A Elevation Window Alterations 18.07.24 ZTT ZTT zev Description Date By Chk

A Elevation Window Alterations 18.07.24 ZTT ZTT Rev Description Date By Chk Survey Tender Construction As Built Tri Star Developments Ltd Talbot Barn, Talbot Street, Chipping Conversion of barn on Talbot Street, Chipping into 3 private properties Proposed Regularization Elevations Drawing No. ZT23-196-30 Revision / 1:50 Date Aug '24 Scales ZTT Drawn Checked

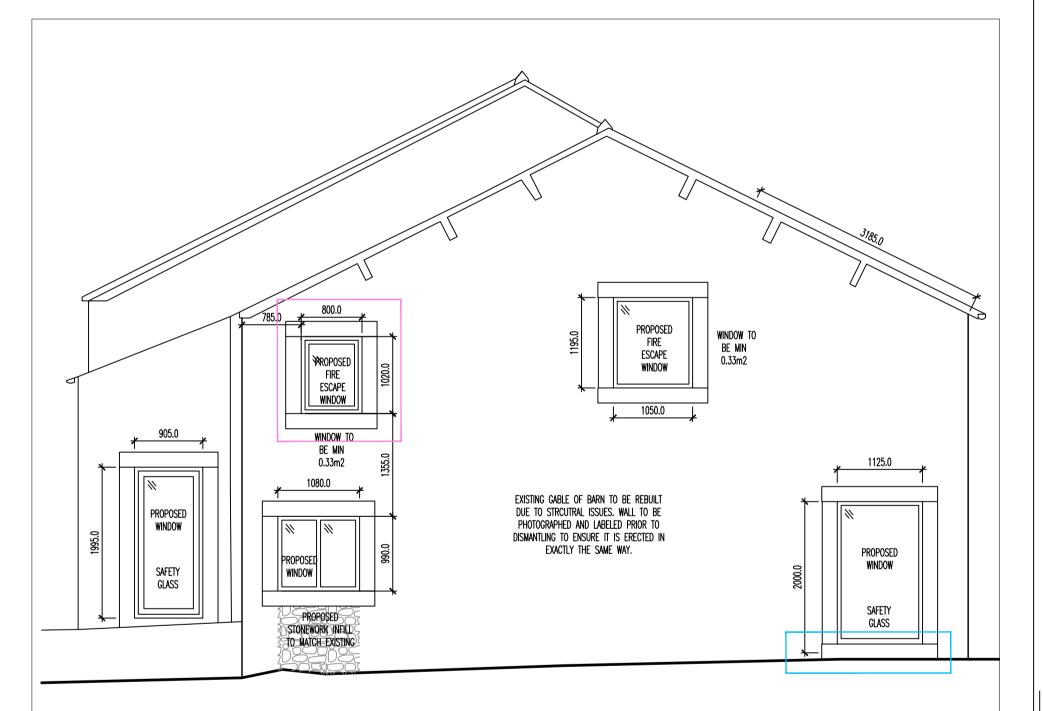
ALL WINDOWS AND DOORS — ALL WINDOWS AND DOORS APART FROM THE ONES HIGHLIGHTED (*) HAVE HAD NEW STONE SURROUNDS INSTALLED. SURROUNDS HAVE BEEN SOURCED FROM A LOCAL QUARRY WHERE THE ORIGINAL STONE CAME FROM. THE STONE IS 200mm THICK AROUND ALL WINDOWS APART FROM ONE MENTIONED BELOW HIGHLIGHTED IN GREEN.

BROWN BOX — WINDOW FORMED IN ROAD SIDE ELEVATION TO BE REMOVED ONSITE AND FILLED WITH STONE TAKEN FROM EXISTING STRUCTURE.

LIGHT BLUE BOX — CILLS TO BE RAISED BY ONE STONE COURSE TO STOP WATER INGRESS FROM THE EXISTING SLOPED ROAD/LAND. INTERNAL FINISHED FLOOR LEVELS ARE APPROX. 0.5m LOWER THAN EXTERNAL FLOOR LEVELS WHICH WILL CAUSE A WATER INGRESS ISSUE IF LEFT ORIGINAL HEIGHT

GREEN BOX — SMALLER WINDOW ON ROAD SIDE ELEVATION TO HAVE STONE SURROUND REDUCED TO 100mm FROM 200mm TO MATCH UP WITH THE EXCISING STONE SURROUND ON SAME ELEVATION

PINK BOX — UPPER WINDOW IN GABLE TO BE REDUCED 200mm IN HEIGHT AND BROUGHT IN FROM THE CORNER OF THE BUILD BY 200mm.

3x REPLACEMENT ROOF LIGHTS TO ROAD SIDE ELEVATION. THESE HAVE NOT YET BEEN FORMED HOWEVER IS REQUESTED UNDER THIS APPLICATION

RED BOX — PROPERTY DOOR HEIGHTS RAISED AS WERE VERY LOW. DOOR OPENINGS TO NOW BE 2050mm

PURPLE BOX — NEW 800x945mm WINDOW FORMED IN ROAD SIDE ELEVATION

ORANGE BOX - NEW 875x835mm WINDOW FORMED IN FRONT ELEVATION.

OFF PROPOSED BEDROOM. THIS IS SHOWN ON THE EXISTING APPROVED PLANS HOWEVER THE SIZE WAS NOT INDICATED.

DARK BLUE BOX — WINDOW TO BE ROTATED HORZONTAILLY DUE TO NEW FLOOR LEVEL.
